Raytac

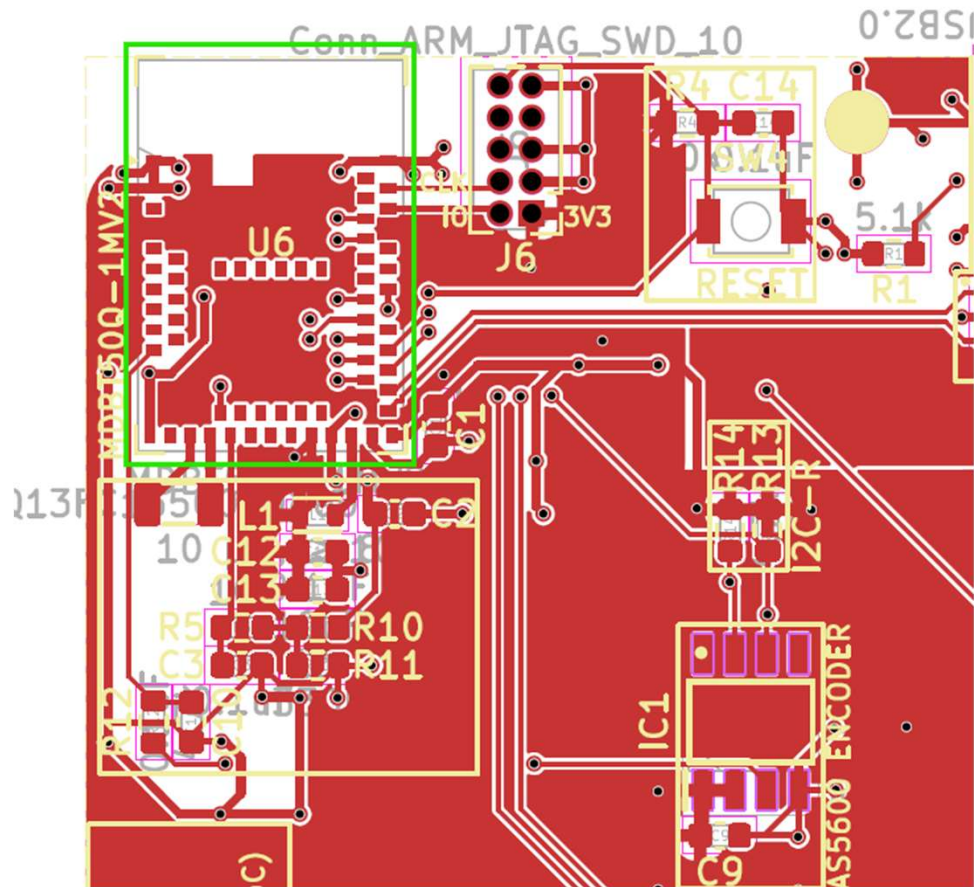
1. Please make sure that the other ground pins of the module are solidly connected to the PCBA ground.

Raytac: If the antenna clearance cannot follow the recommended layout, the antenna radiated performance should be verified with the final product or housing to ensure it meets the required performance.

Top View

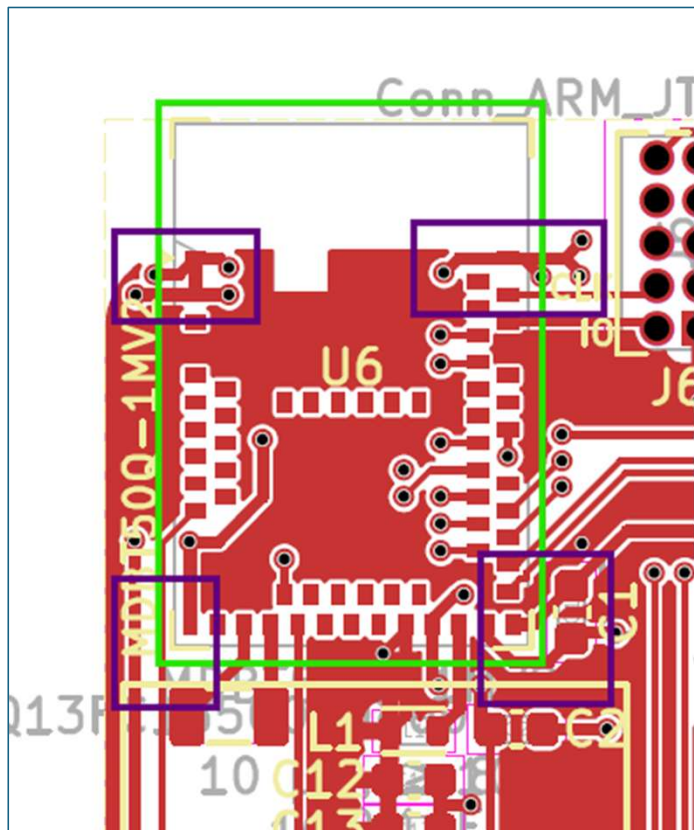
Raytac: Please add more ground vias according to the RF layout recommendations.(see Chapter 2.3 of the datasheet)

Top View

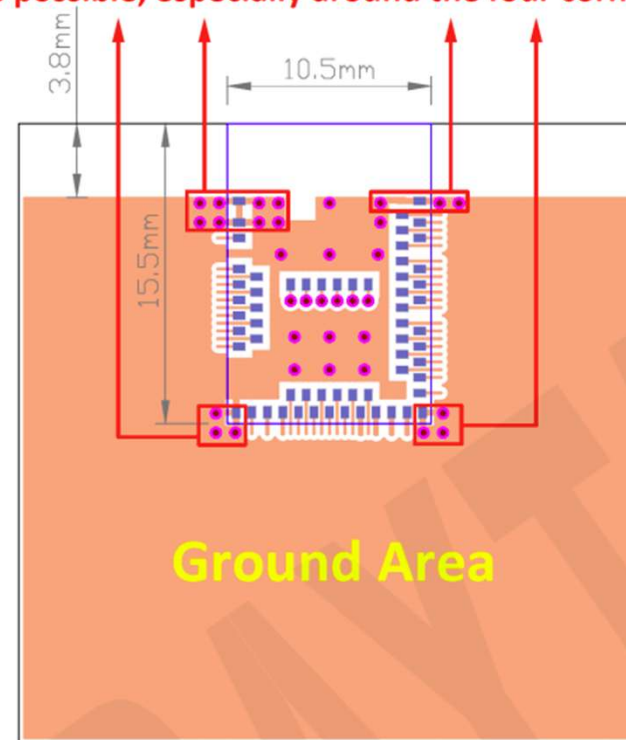
Please add via holes in GROUND area as many as possible, especially around the four corners.

1. Please check which function the red plane on the BOT layer belongs to - power or ground? It is not recommended to fill the entire power plane due to EMI and ESD concerns. However, If it is a ground plane, the module's ground pins should be connected to the it.
2. The PCB ground planes on the top and bottom layers should be solidly connected through ground vias. It is also recommended to place a ground guard with vias along the outermost edge of the board to enhance ESD protection.
